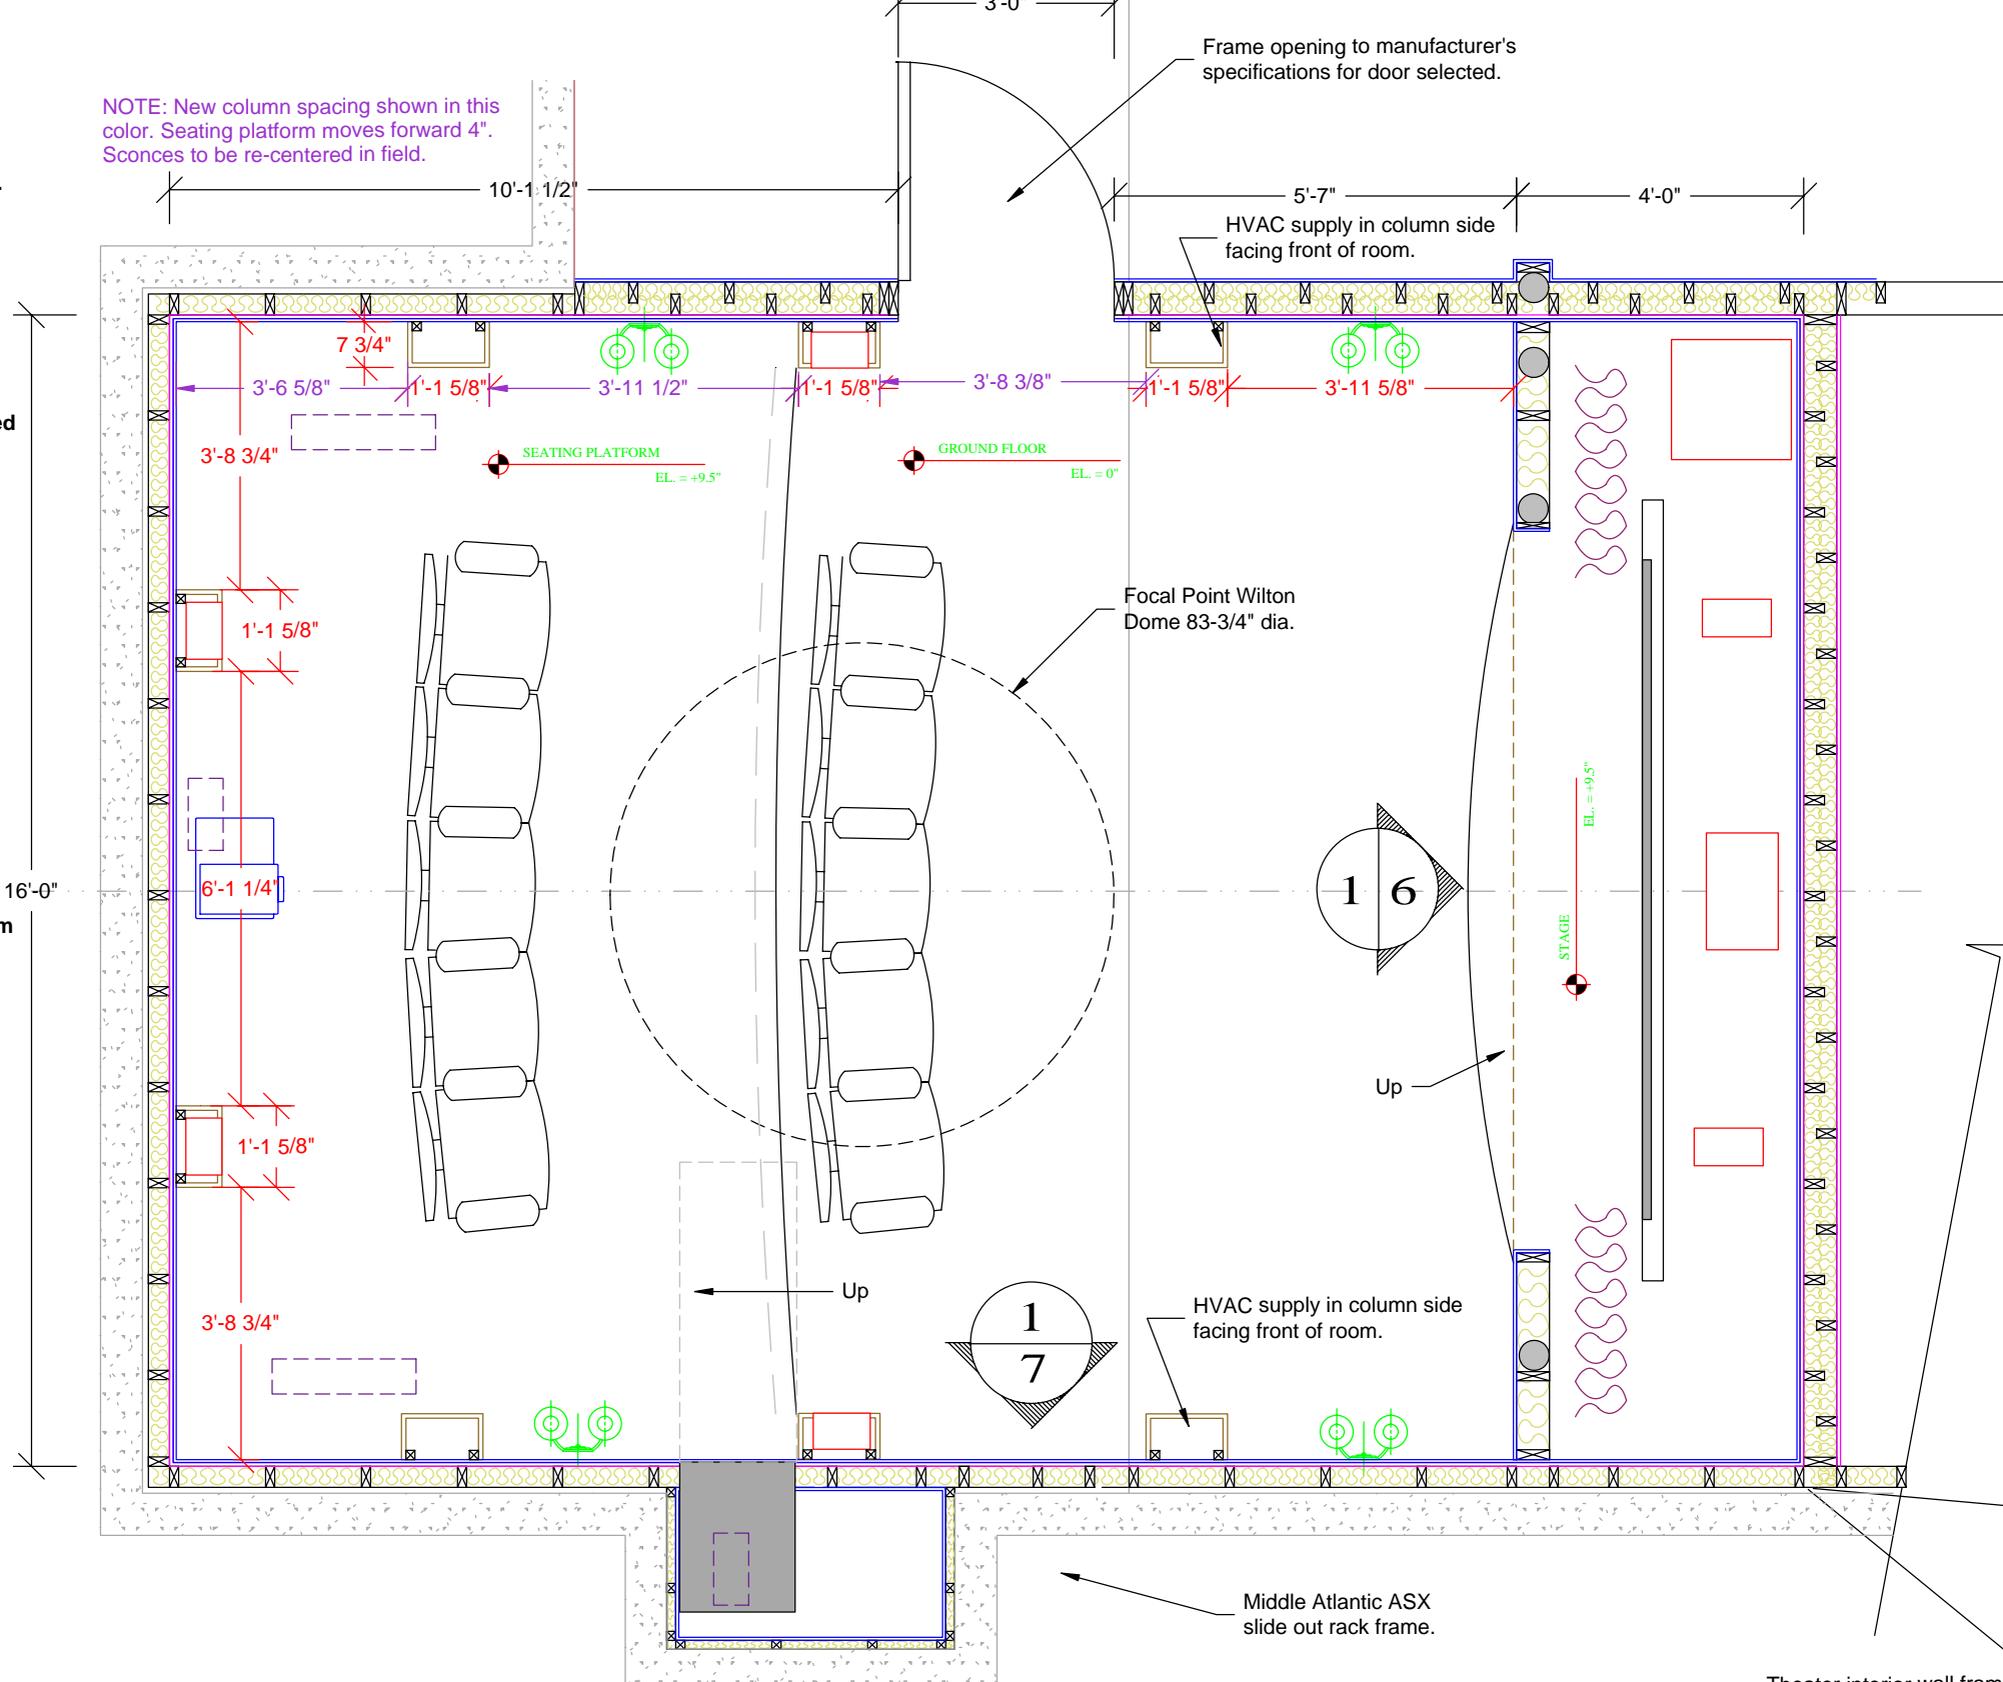
NOTE: New column spacing shown in this color. Seating platform moves forward 4". Sconces to be re-centered in field.
